SERVICE NO. 1331 LETTER

IMPROVED SPRING ATTACHMENT PLATE

Figure 1
Spring Attachment Plate Installation
(PA-44-180 shown, other models similar)

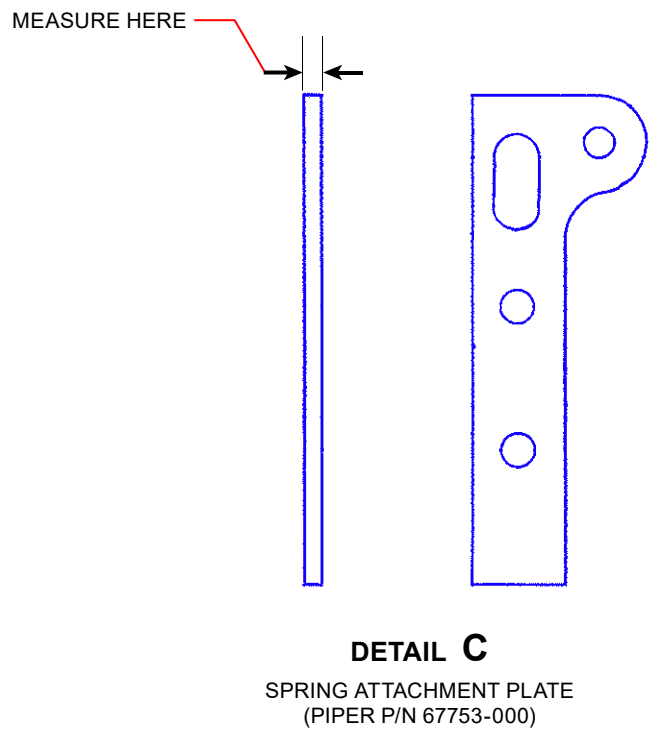
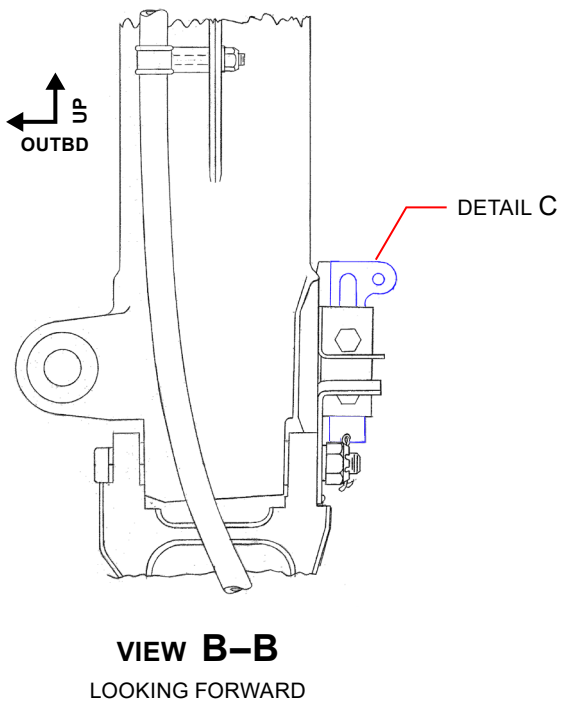
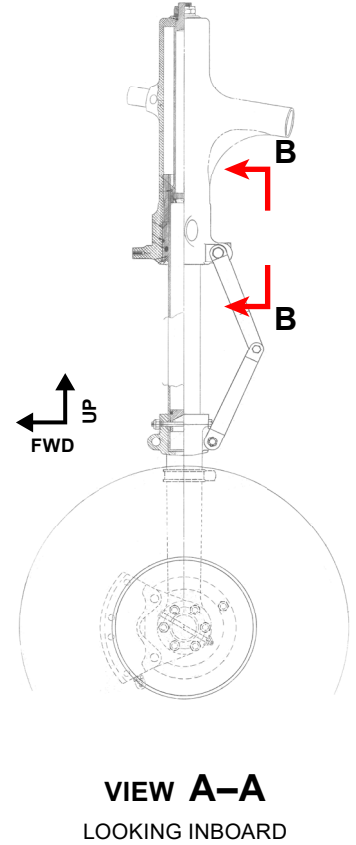
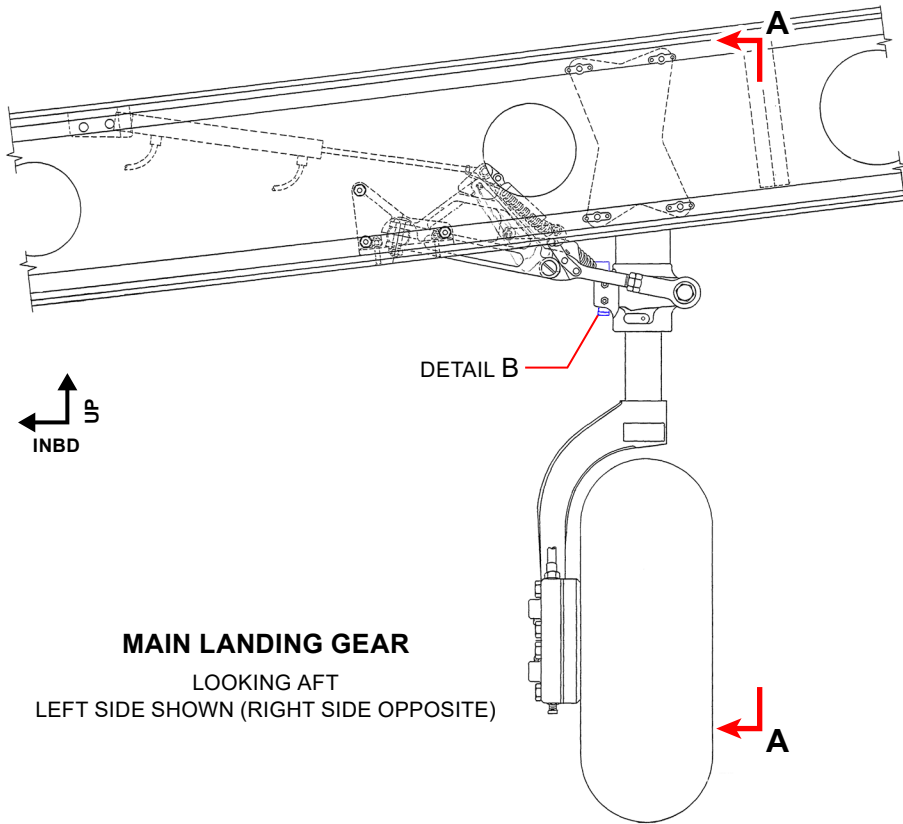
- a. Locate the spring attachment plate on each main landing gear as shown in Figure 1.
 - b. Measure the material thickness of each spring attachment plate.

- If the thickness of the plate is 0.090 inches, no further action is required; proceed to step 3.
 - If the thickness of the plate is 0.063 inches, further action is required; proceed to step 2.

2. Order and replace the spring attachment plates, Piper P/N 67753-000. Refer to Chapter 32-10-00 of the applicable Piper airplane maintenance manual (AMM) or the appropriate section of the applicable Piper service manual (SM) for instructions on removal and installation of main landing gear components. Replace fastener hardware on condition.
NOTE: Refer to the section index guide of the applicable service manual; the section on retractable landing gear varies between each Piper SM.
